DATE:	06/25/25
TO:	All Bidders
FROM:	David Cienfuegos, Purchasing Specialist
SUBJECT:	Addendum 1 – Bid 711 Moorpark College SSA HVAC Replacement

MOORPARK COLLEGE 7075 CAMPUS ROAD, MOORPARK, CALIFORNIA 93021 VENTURA COUNTY COMMUNITY COLLEGE DISTRICT

DEPARTMENT OF MAINTENANCE & OPERATIONS	SCALE: STUDENT SERVICE ANNEX AS SHOWN HVAC REPLACEMENT PROJECT			
	DATE:		SHEET NO.	1
7075 CAMPUS RD.	2-2-23			1
MOORPARK, CA. 93021 PHONE: (805) 378-1454 FAX: (805) 378-1593	BLDG. NO.	NOTES AND SCHEDULES	M1	1

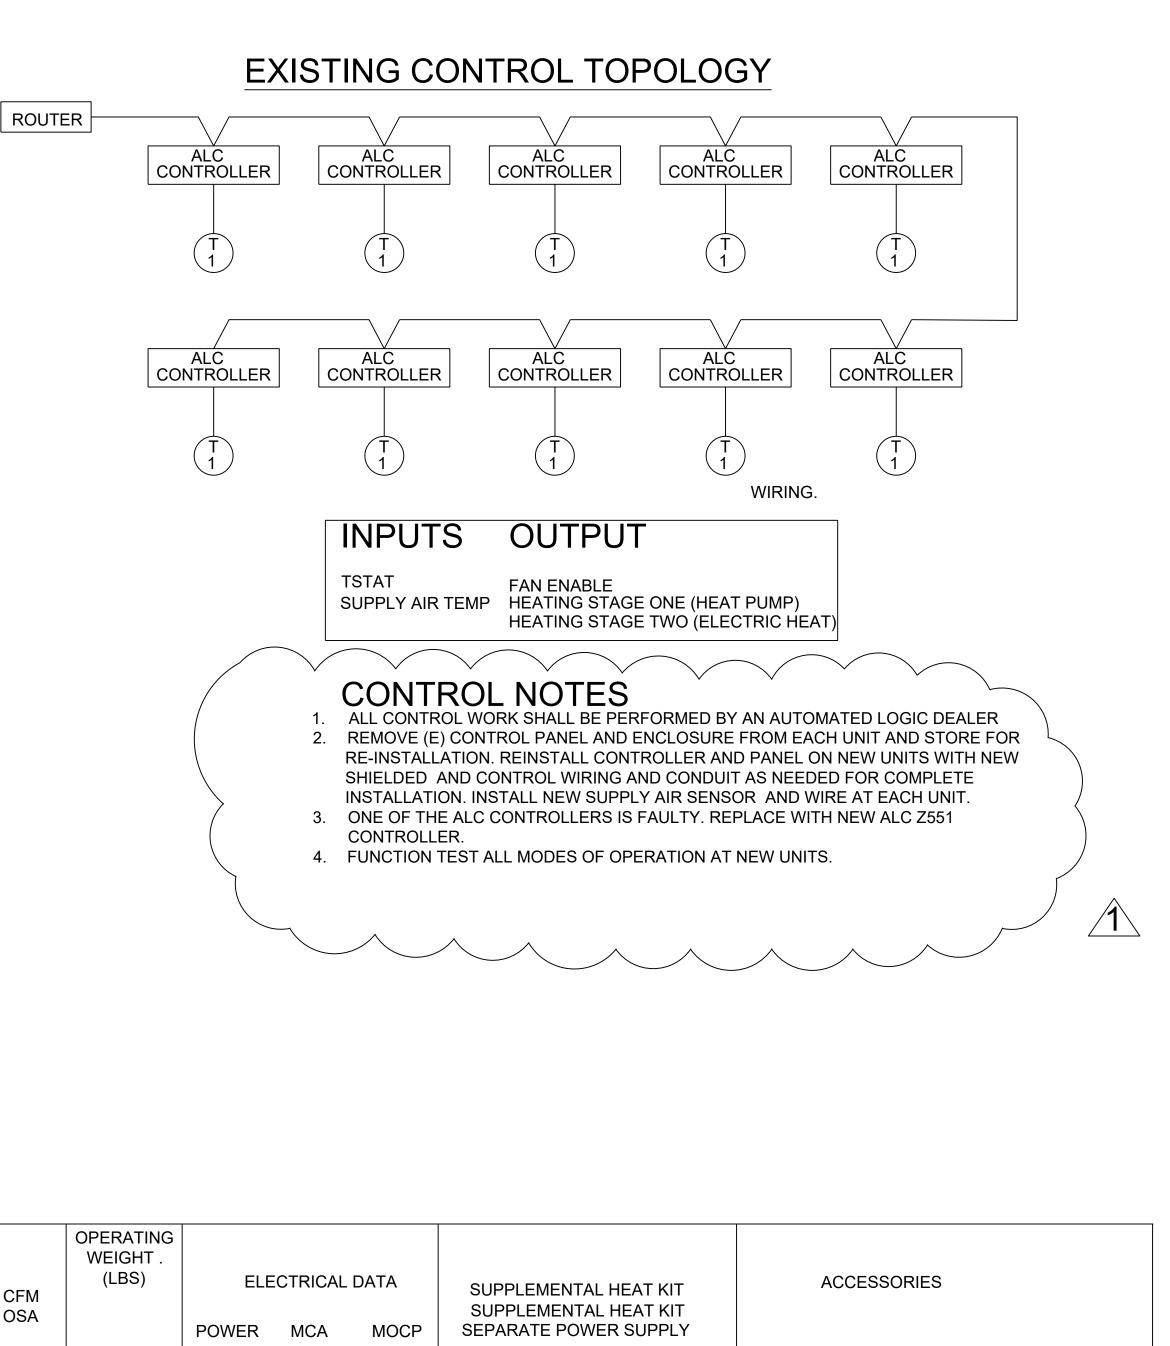
Sheet M1.0:

- 1) Remove and reinstall existing UV light assembly. See attached M1.0.
- 2) Remove and reinstall existing ALC control systems. Replace one non-functional ALC controller. See attached M1.0

1. REMOVE (E) UV LIGHT SYSTEM AT EACH UNIT AND RE-INSTALL IN NEW UNIT DUCTING. PROVIDE ACCESS PANEL IN SHROUD FOR LIGHT CHANGING. CONNECT TO NEW UNIT POWER SUPPLY DOWNSTREAM OF DISCONNECT. REINSTALL VIEW PORT AND WARNING LABELS.

DEPARTMENT OF MAINTENANCE & OPERATIONS	SCALE: AS SHOWN	STUDENT SERVICE ANNEX HVAC REPLACEMENT PROJEC	Т
7075 CAMPUS RD.	DATE: 2-2-23	MECHANICAL FLOOR	SHEET NO.
MOORPARK, CA. 93021 PHONE: (805) 378-1454 FAX: (805) 378-1593	BLDG. NO.	PLAN	M2

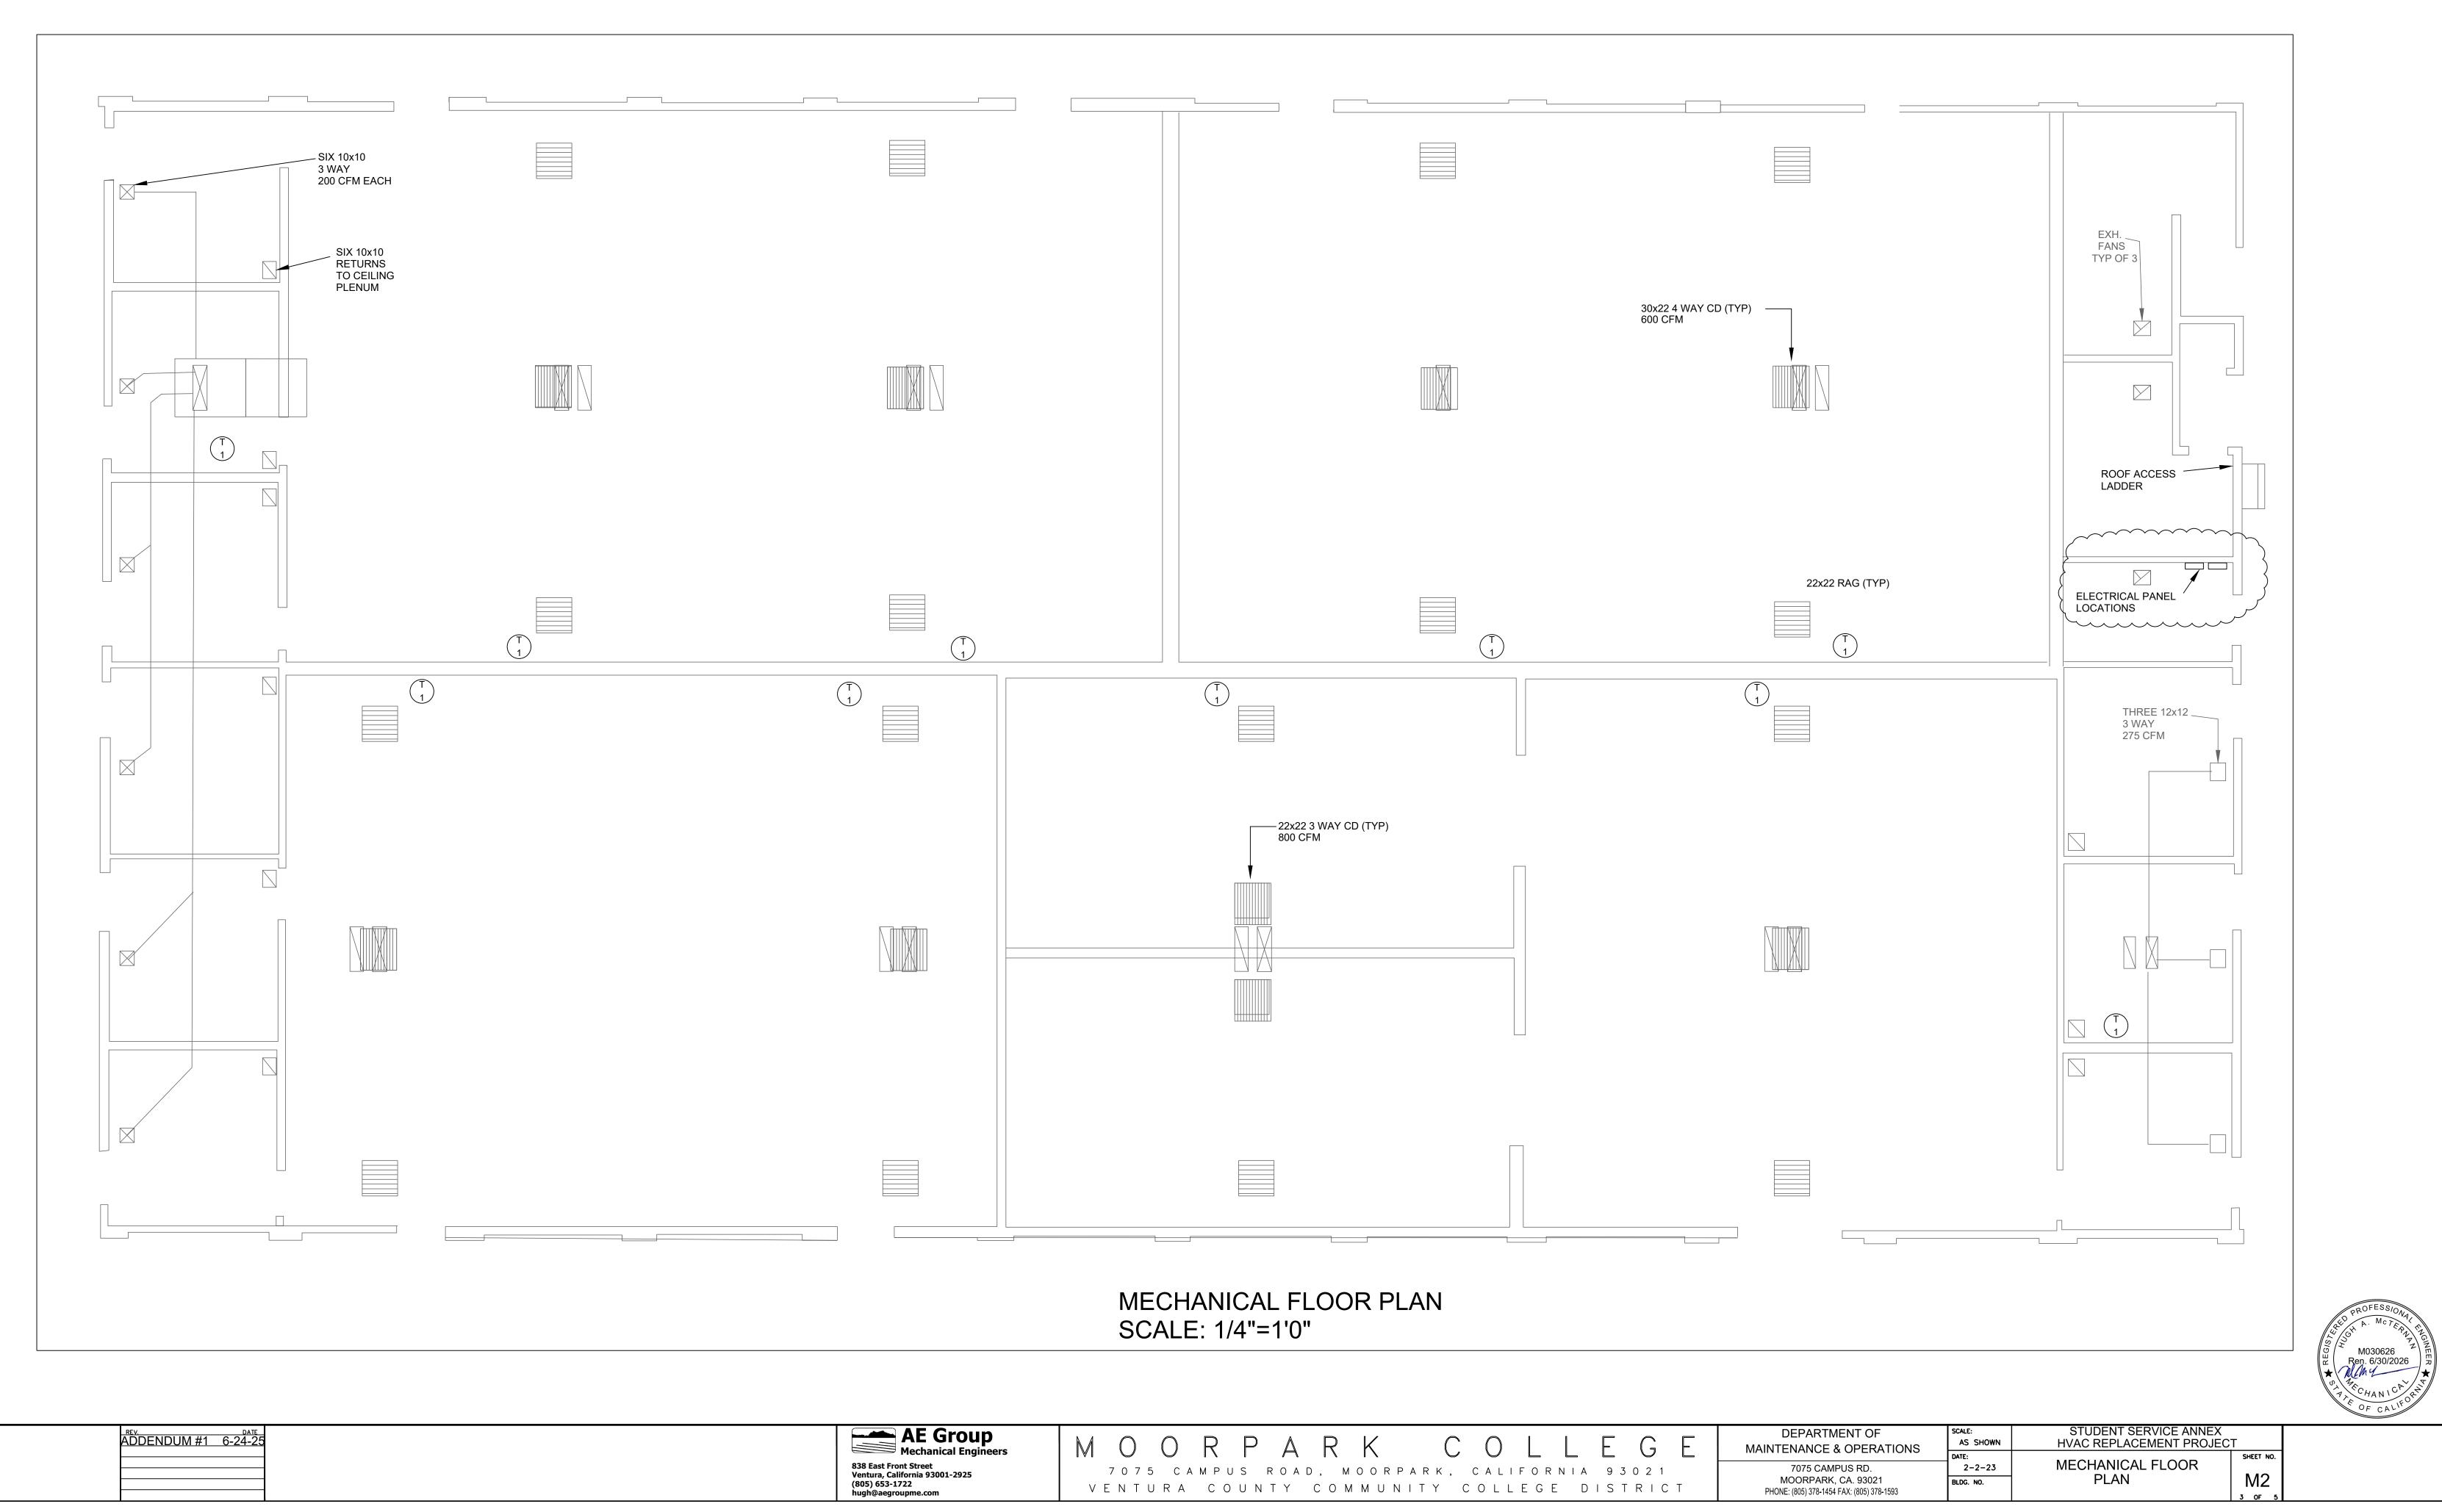
Sheet M2.0:

1) Delete below roof condensate piping and drywall

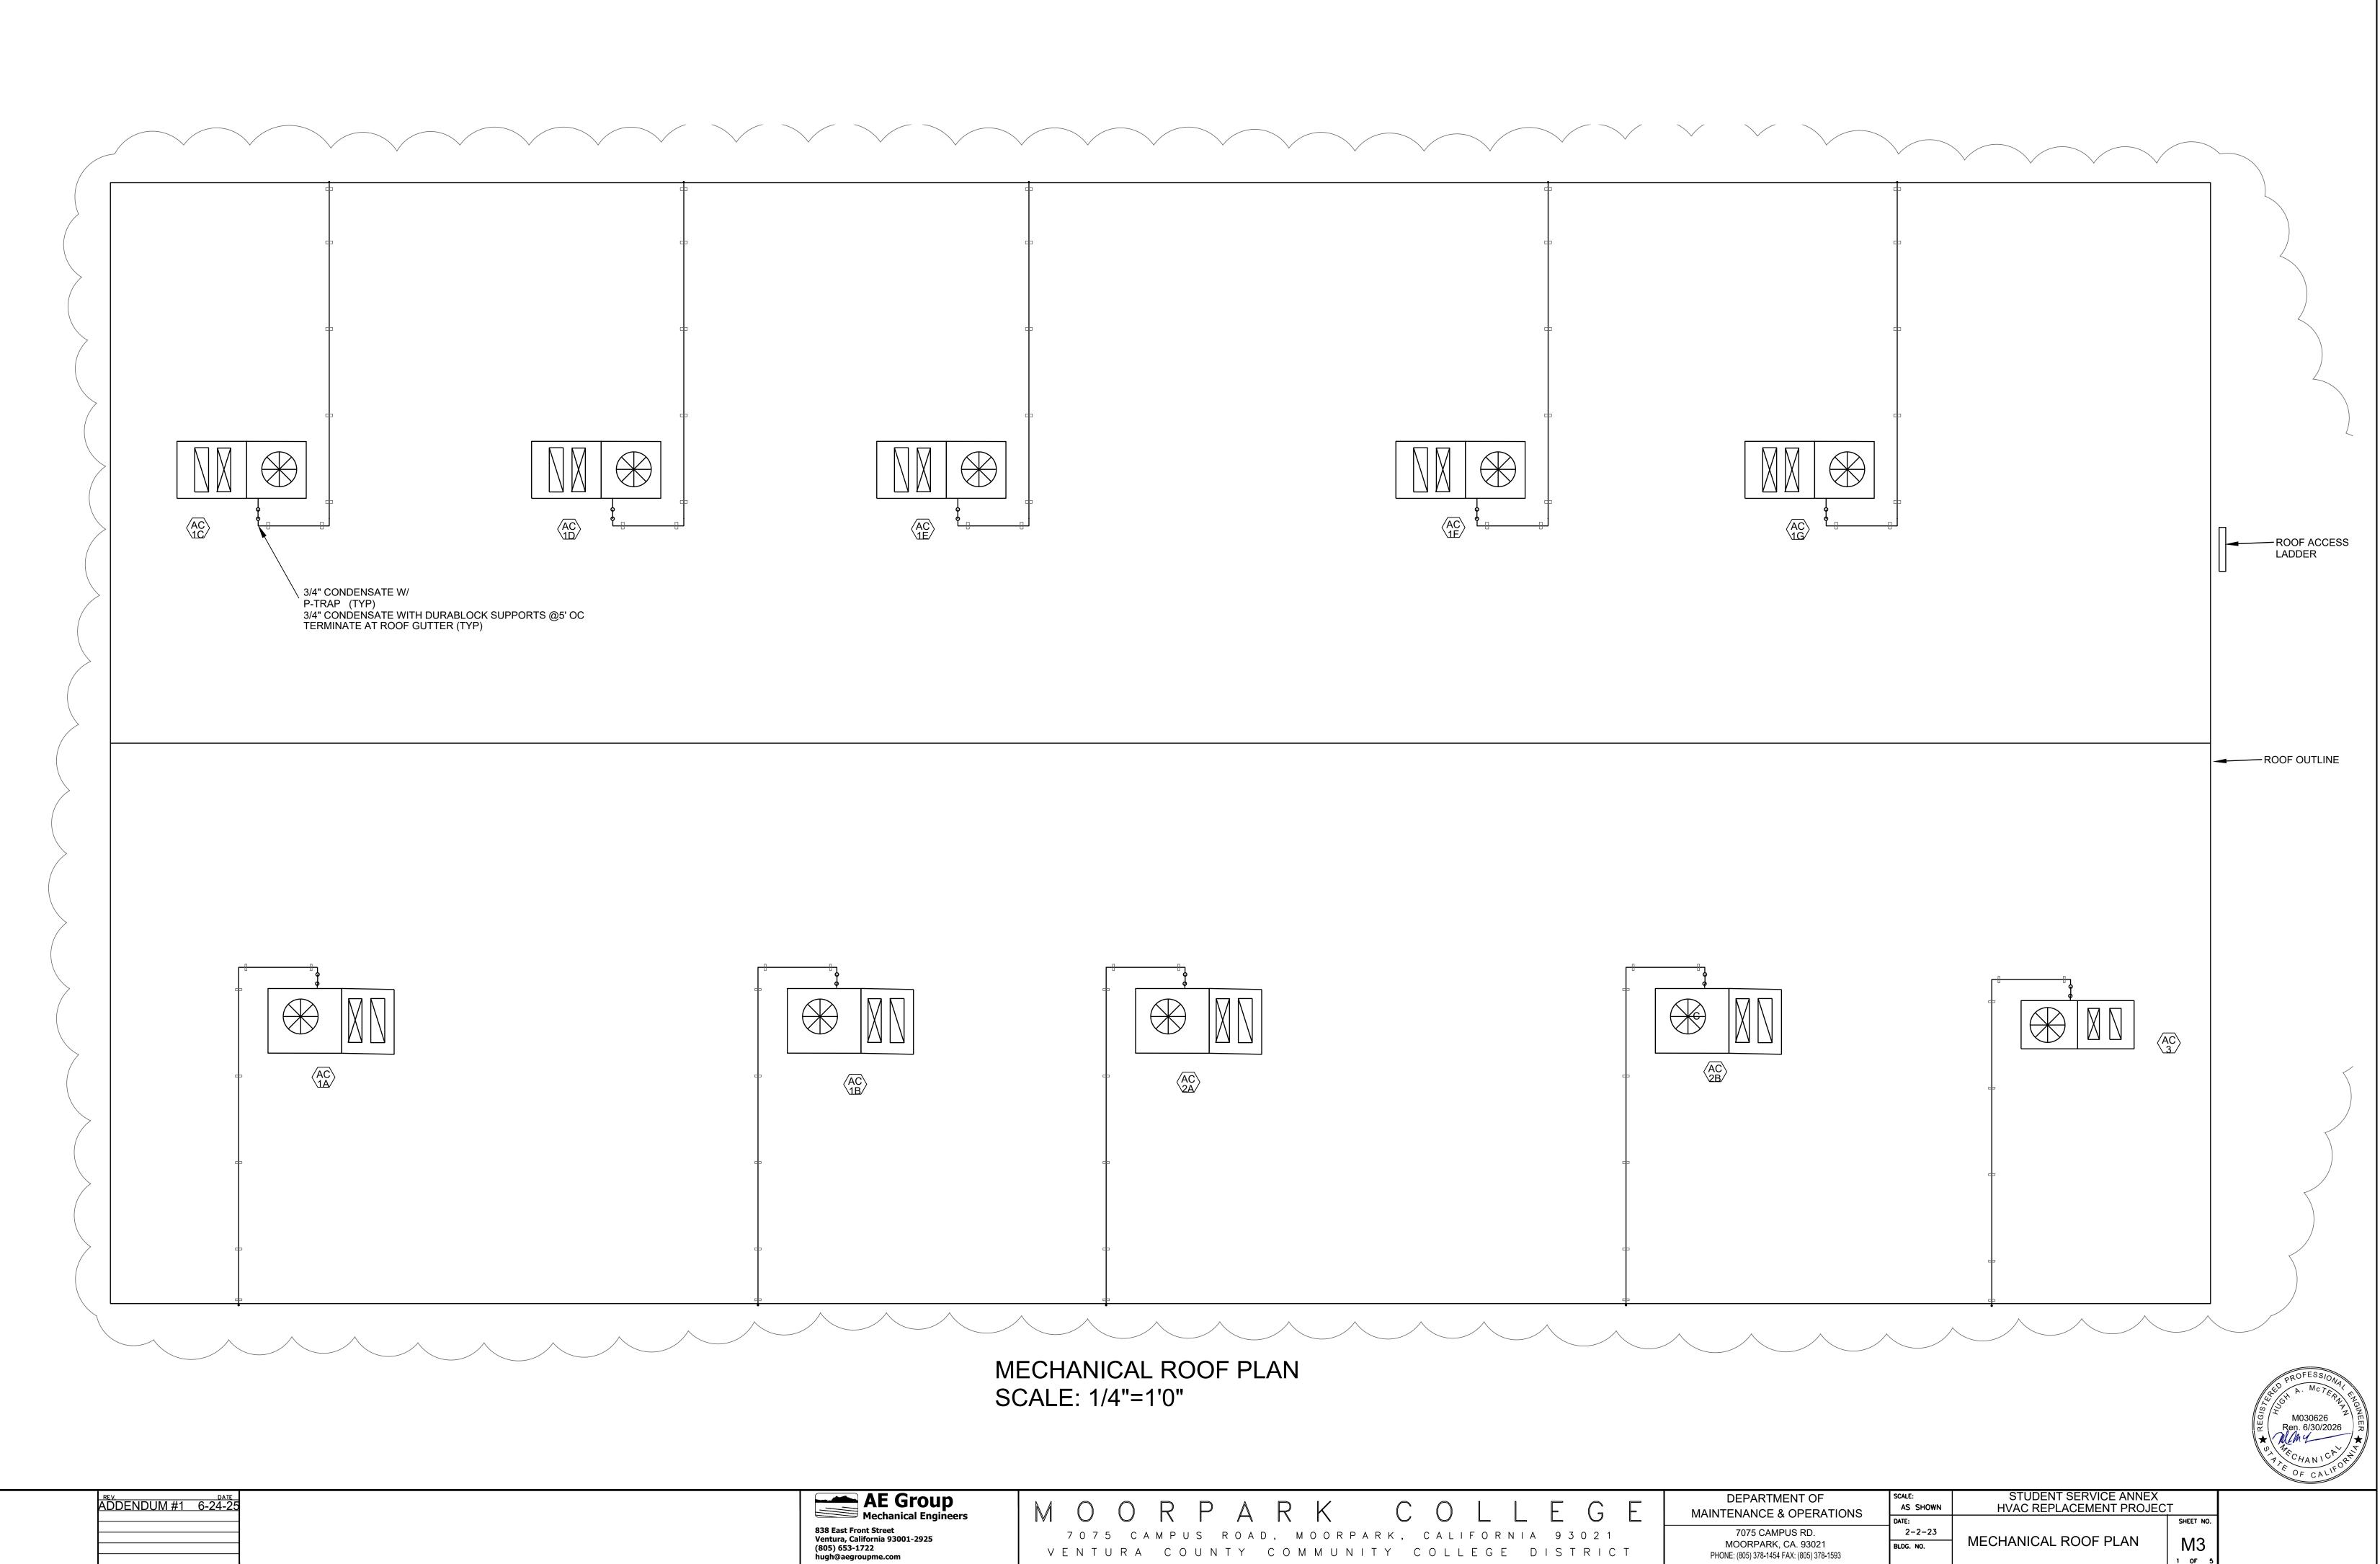
Sheet M3.0:

1) Install copper with soldered wrot copper fittings condensate piping at each unit on Durablocks @ 5' oc and terminate at roof gutter.
